7A Design Response to Appendix B, ABWR LRB Instrumentation and Controls

The NRC requested considerable additional information specific to this equipment in Appendix B. The NRC requests, along with responses as revised, are provided in this appendix to Chapter 7.

Figure 7A-2 Structure for Control and Instrumentation System Design

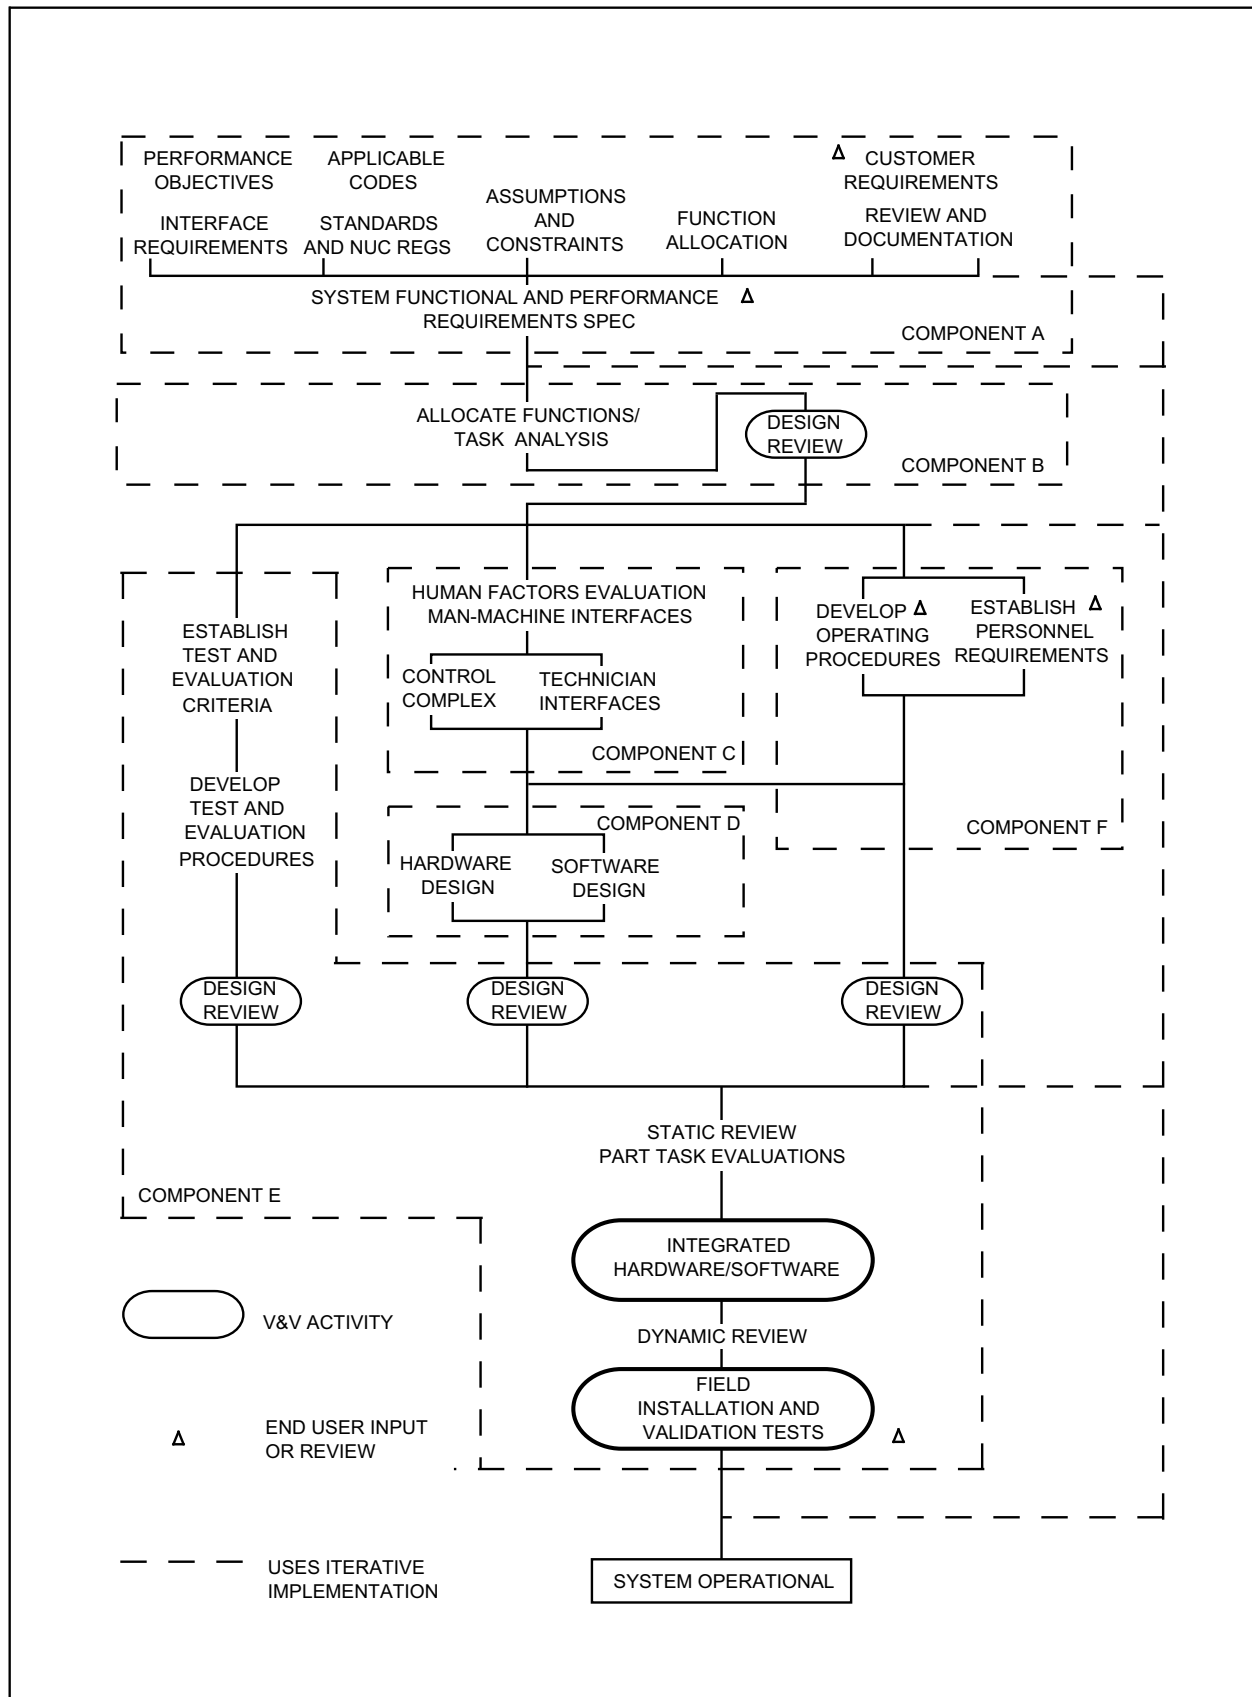
NRC Request—Provide a comparison of the design with the following:

Figure 7A-2 illustrates the structure utilized for ABWR control and instrumentation system design which incorporates subject guidelines.
